SRS test source calibration: measurement bandwidth (comment r03-9)

> P802.3cd ad hoc, 27th June 2018 Jonathan King, Finisar

SRS test source calibration measurement bandwidth in D3.2

What does the D3.3 bandwidth description look like ?

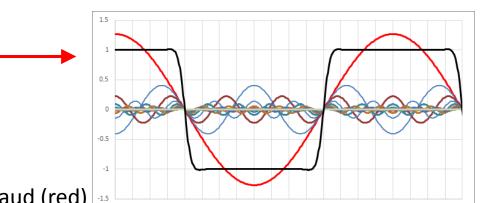
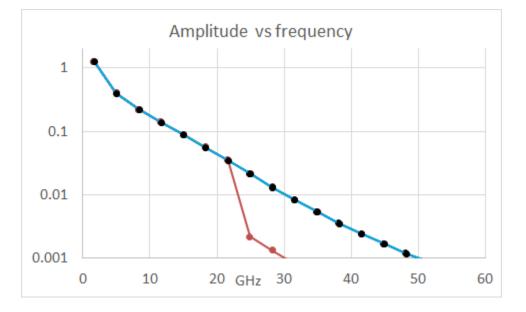
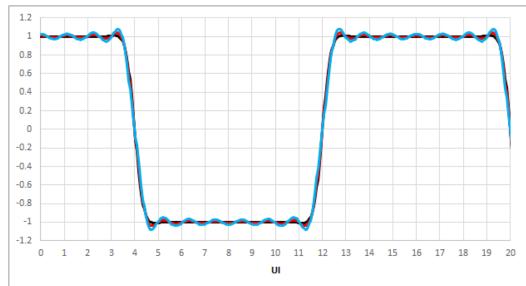
- Removes the need to meet a fourth-order Bessel-Thompson response for frequencies above 0.9 x Baud
 - Allows any phase response provided it doesn't exceed the magnitude response of a BT4 up to 0.9 x Baud
 - No constraints at all beyond 1.5 x Baud
 - This seemingly precise definition makes it even less likely that a casual reader will pay attention to warnings about jitter and noise given, for example, in 139.7.9.3.

-10.9 dB (electrical) = 28% voltage

For a BT4 filtered white noise source, area represents 2.8% power

D3.3 SRS bandwidth applied to transition time measurement -1

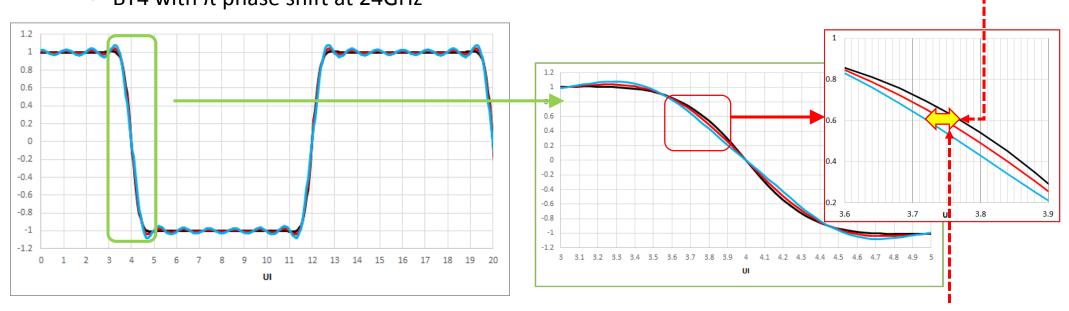
- Square wave test pattern, 3 conditions:
 - BT4 response per D3.2, one answer
 - BT4 with components attenuated by factor of 10 at 0.9xBaud,
 - BT4 with π phase shift at 24GHz

Range of responses allowed by D3.3

• ~20% variation in transition time measurement

Transition time error vs HF spec -1

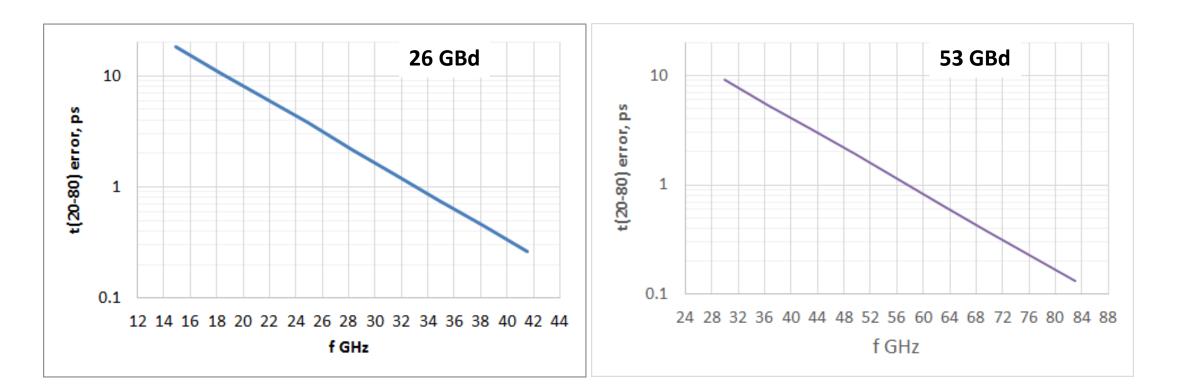
• Transition time variation (ps) vs frequency (GHz) up to which BT4 response is required

Transition time error vs HF spec -2

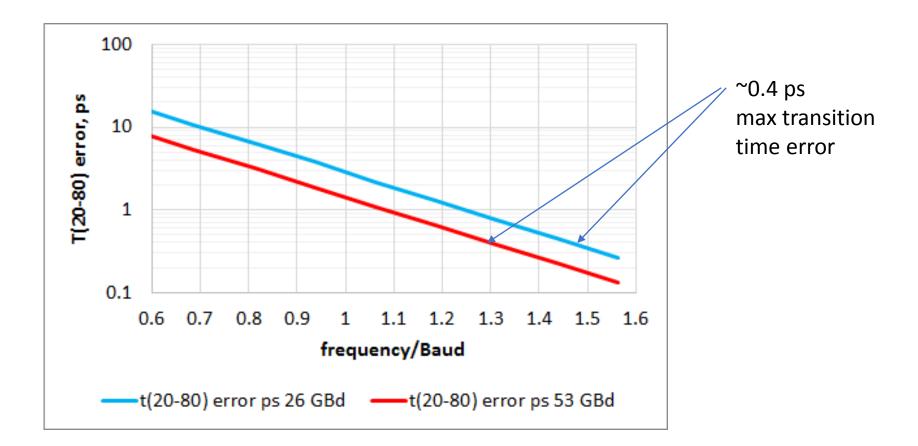
Transition time variation (ps) vs frequency/Baud up to which a BT4 response is required

- The SRS test source calibration measurement bandwidth in D3.3 leaves significant portions of the measurement frequency substantially undefined. It should not be applied to transition time measurements or TDECQ as is.

- If a consistent bandwidth definition for TDECQ, transition time and SRS test source calibration is desired, some options are:
 - 1) Revert to draft 3.2 definition, but change this sentence: "Compensation may should be made for any deviation from an ideal fourth-order Bessel-Thompson response."

- 2) Add a sentence to the D3.3 or D3.2 SRS test bandwidth definition to draw attention to the need for well behaved test measurement bandwidths, for example: "Deviation from an ideal fourth-order Bessel-Thompson response may cause excess jitter and amplitude variation which will make measurements inaccurate, see 139.7.9.3."

- 3) Change the D3.3 SRS test source measurement bandwidth definition for 26GBd lanes to "...to at least 1.5×26.5625 GHz and at frequencies above 1.5×26.5625 GHz the response should not exceed the Bessel-Thomson response."

"...to at least 1.3×53.25 GHz and at frequencies above 1.3×53.25 GHz the response should not exceed the Bessel-Thomson response."

Note: Limits transition time variation to <0.4 ps and TDECQ variation to less than ~0.1 dB (TBC)
